Re: RFCA Guardrail Test

Picco Engineering has completed our review of the test performed by Infrastructure Health & Safety Association for the temporary guardrail strength.

DWG. TITLE		TEMPORARY FLOOR GUARD DETAIL		1	11/12/2015	ISSUED FOR CONSTRUCTION			
 <p>8611 Jane Street Suite 200 Concord, Ontario Canada L4K 2M6 T. 905.760.9688 F. 905.760.9699 www.picco-engineering.com</p>	PROJECT	RESIDENTIAL							
	CLIENT	RESIDENTIAL FRAMING CONTRACTORS ASSOCIATION				DATE	DEC. 2015	DRAWN BY	DS
		160 APPLEWOOD CRESCENT, SUITE 31 CONCORD, ON. CANADA L4K 4H2 905.669.2119 MAIN 905.669.9713 FAX				SCALE	AS NOTED	CHECKED BY	AK
					JOB NO.	08-107T	DWG. NO.		SK-7a

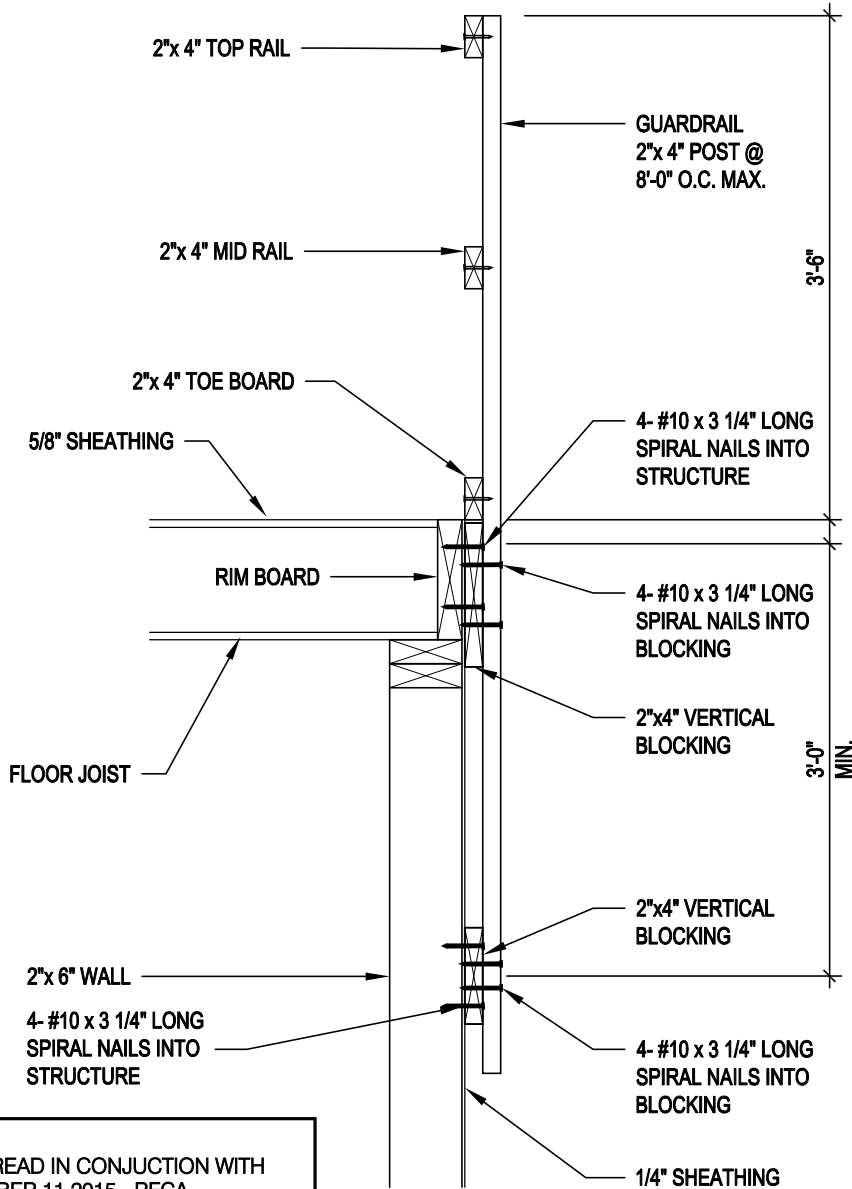
Based on the results of this testing and the successful historic use of these railings, it is our opinion that the temporary railing is acceptable. This acceptance is contingent that the installation on site meets or exceeds the requirements of the details provided in SK-7a by Picco Engineering dated December 11, 2015 and the assembly tested. The guardrail must be constructed in strict conformance to the detail provided.

THIS DETAIL MUST BE READ IN CONJUNCTION WITH LETTER DATED DECEMBER 11 2015 - RFCA GUARDRAIL TEST AND INFRASTRUCTURE HEALTH AND SAFETY ASSOCIATION TEST - RESIDENTIAL TEMPORARY FLOOR GUARDRAIL TESTING PERFORMED BY PETER VI.

THIS SKETCH IS BASED ON INFORMATION PROVIDED BY RESIDENTIAL FRAMING CONTRACTORS ASSOCIATION. THIS CONFIGURATION IS WHAT IS BEING USED AND ACCEPTED BY MINISTRY OF LABOUR INSPECTORS.
